CONSTRUCTION PLANS FOR CARRIAGE MEADOWS SOUTH AT LORSON RANCH

STREET, STORM SEWER, AND POND CONSTRUCTION PLANS

COVER SHEET
STREET, STORM SEWER AND POND
CONSTRUCTION PLANS

DATE: MARCH, 2017
 PROJECT NO. 100.030
 SHEET NUMBER C6.5
 TOTAL SHEETS: 37

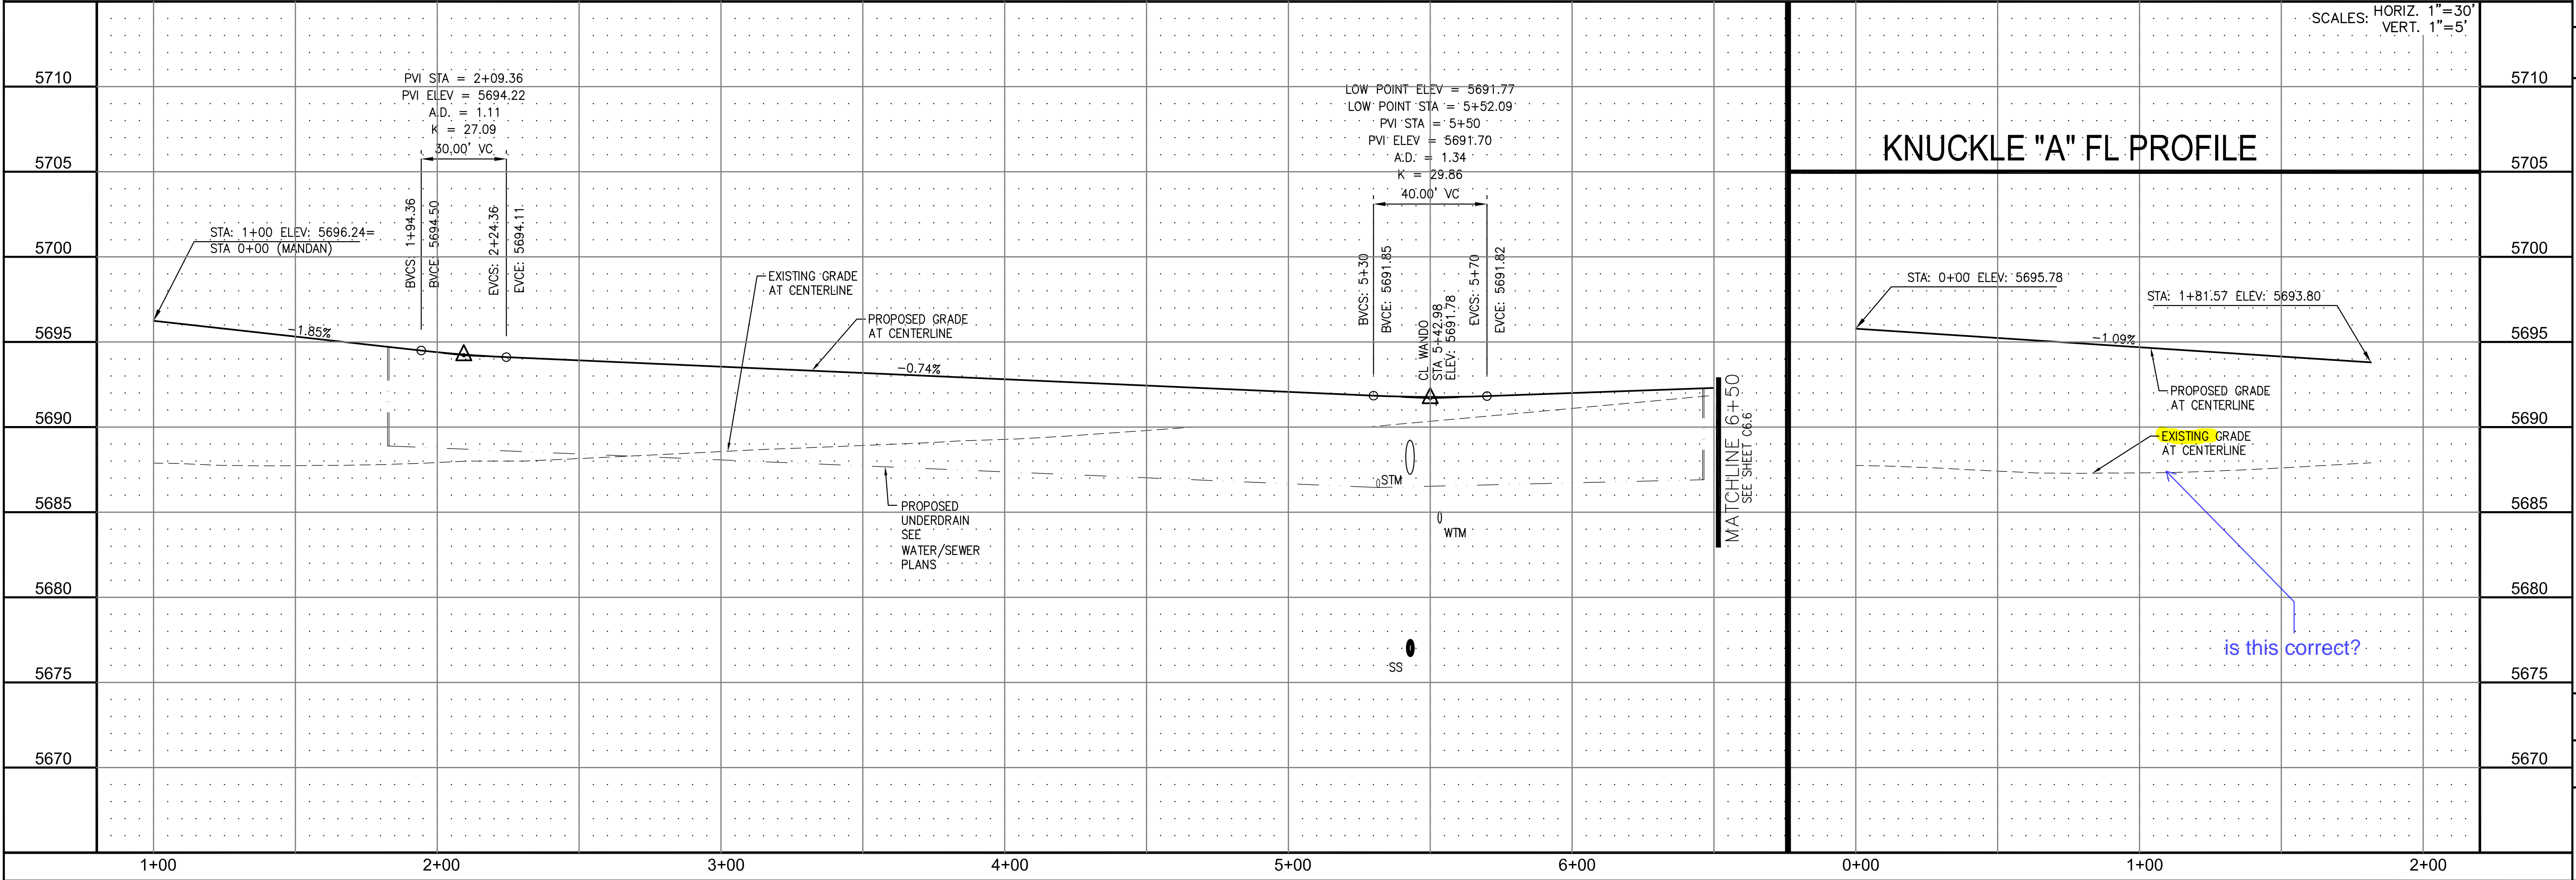
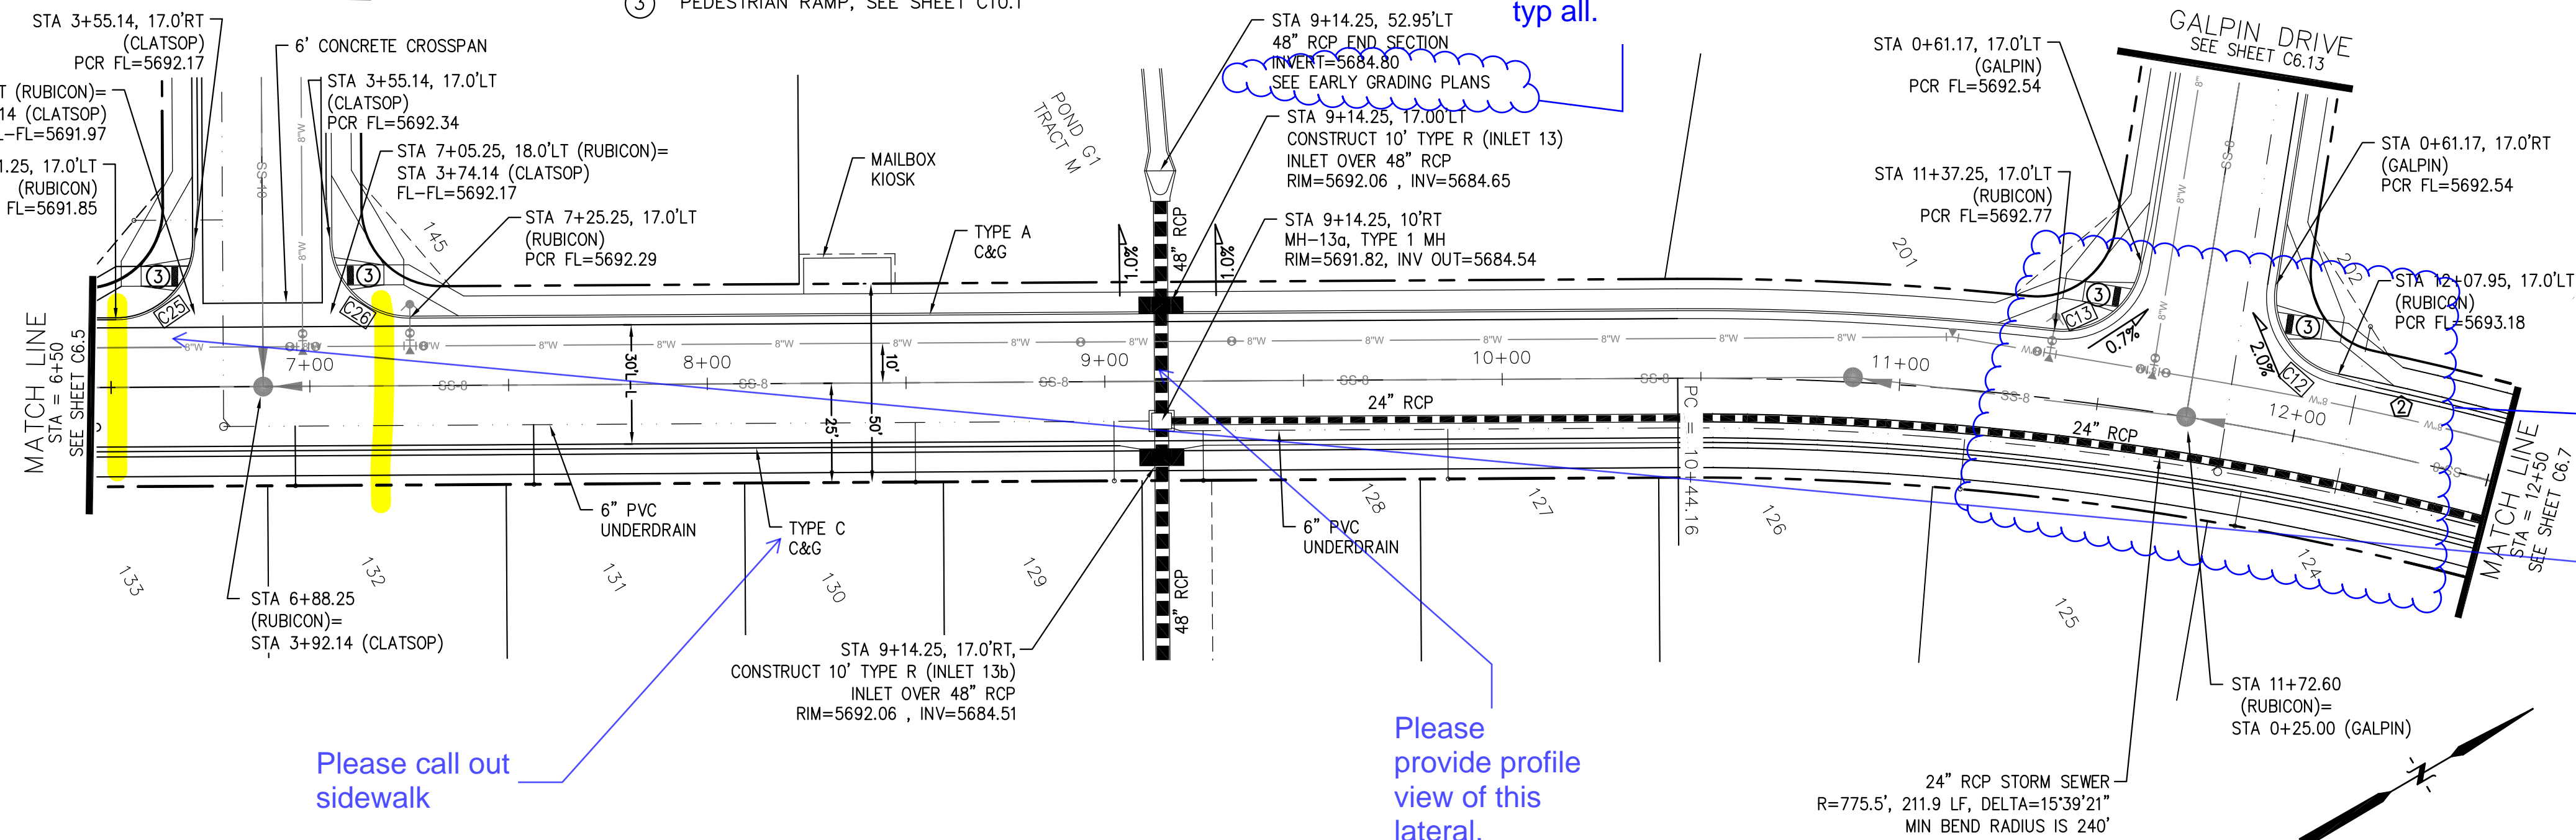
is this correct?

DATE: MARCH, 2017
PROJECT NO. 100.030
SHEET NUMBER **C6.6**
TOTAL SHEETS: 37

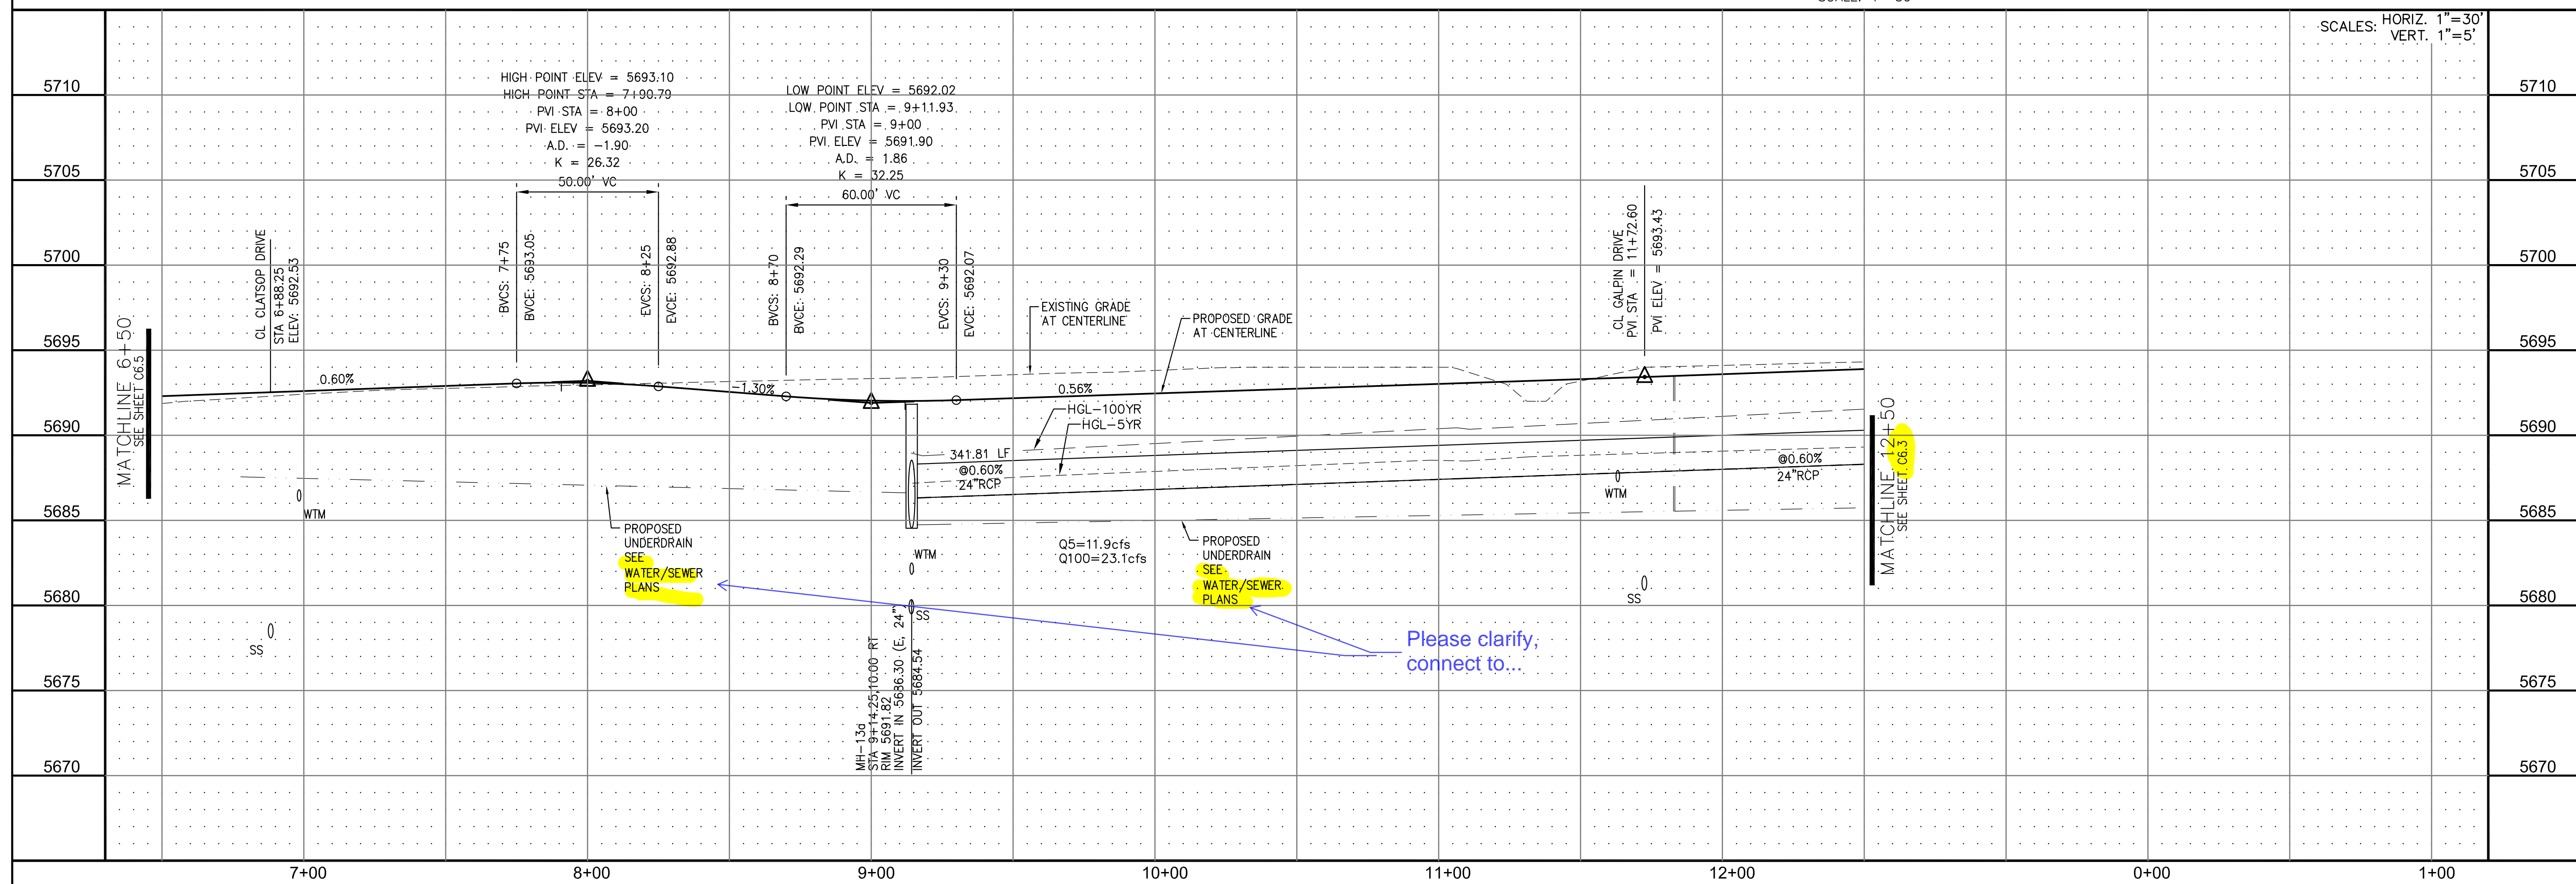
Please add engineer and approval date, typ all.

Please provide profile view of this lateral.

Pedestrian crossing required at all T intersections. Typical all.

DATE: MARCH, 2017
 PROJECT NO. 100.030
 SHEET NUMBER **C6.8**
 TOTAL SHEETS: 37

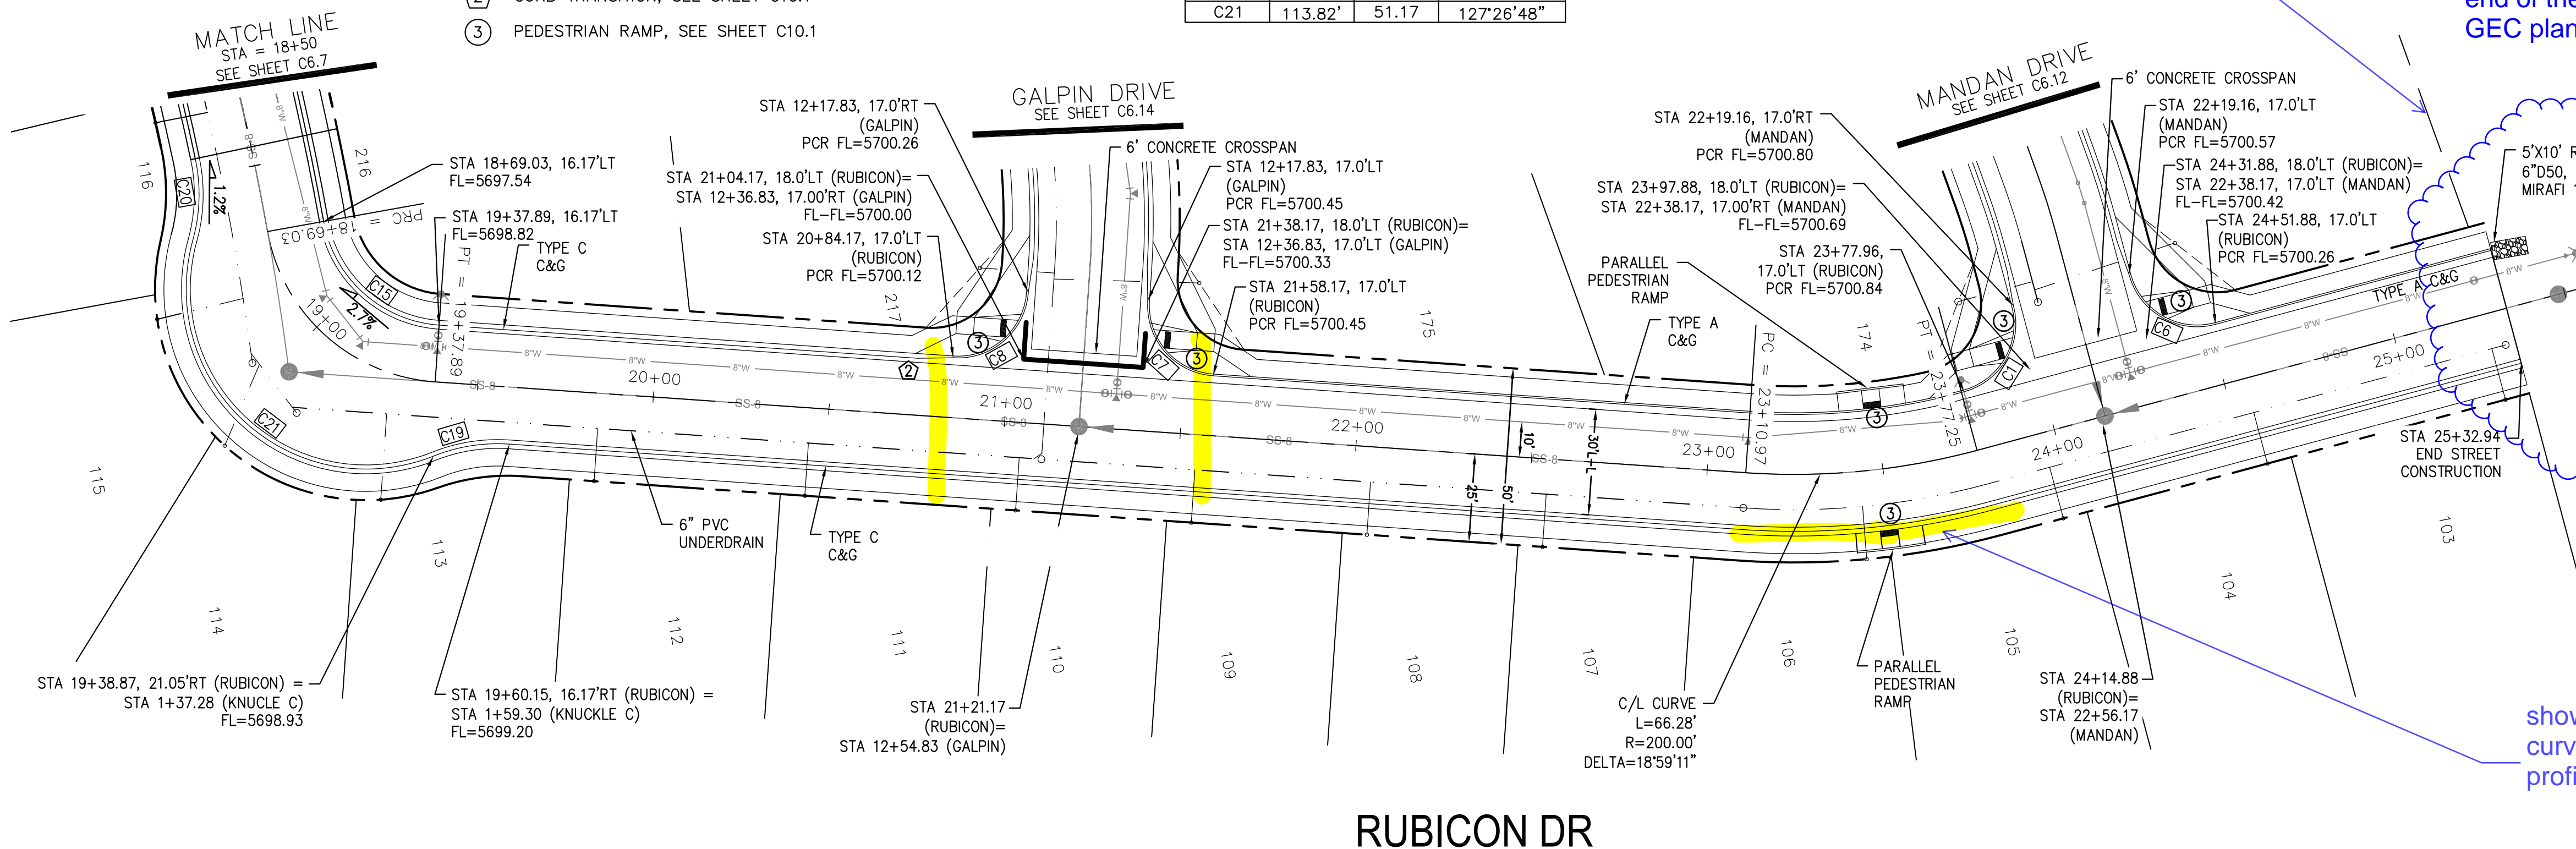
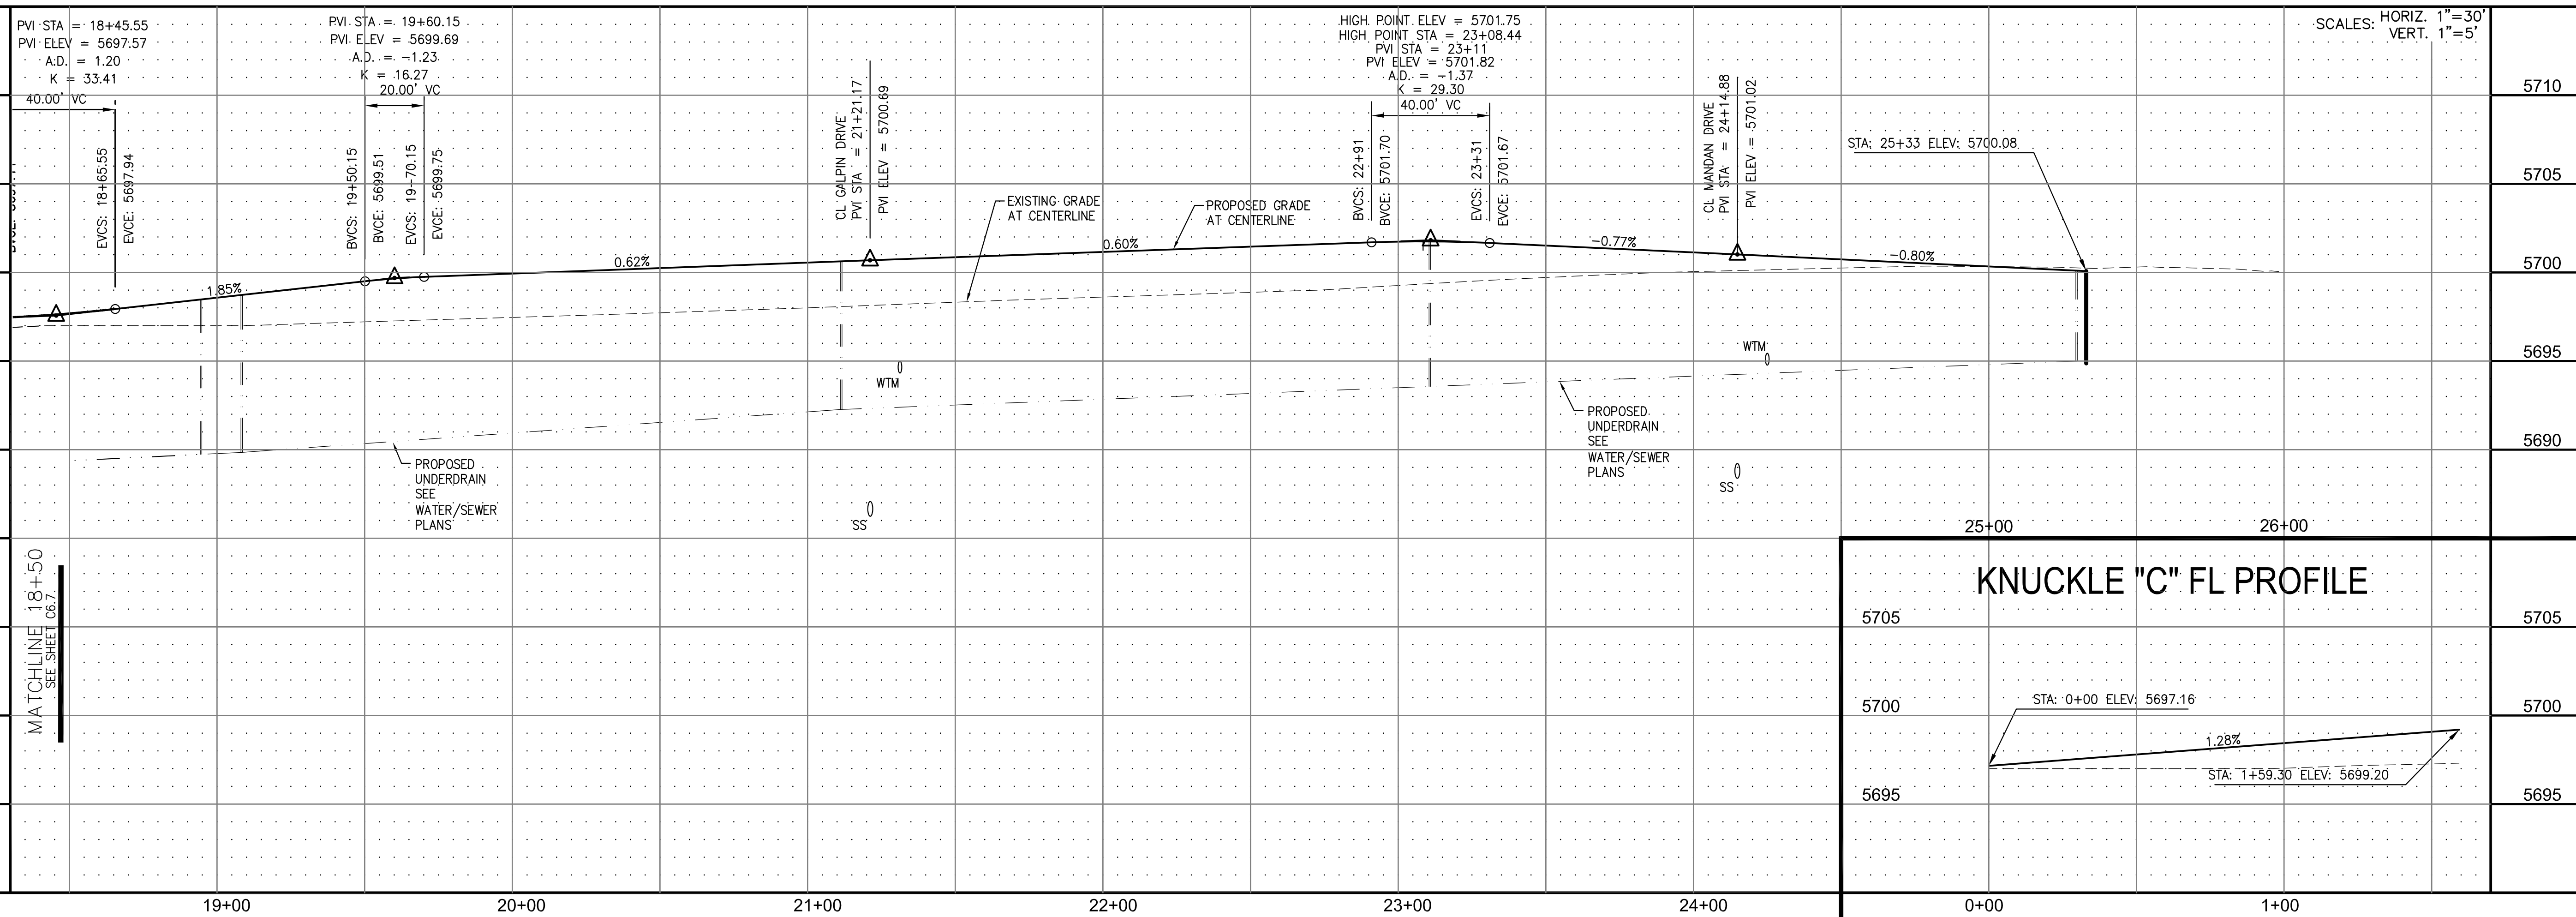
Please provide extents of lot, construction should go to furthest lot line (102 or 103).

Please provide protection on both C&G end sections as well as across the end of the EOA, on a GEC plan.

show outside curve FL profile.
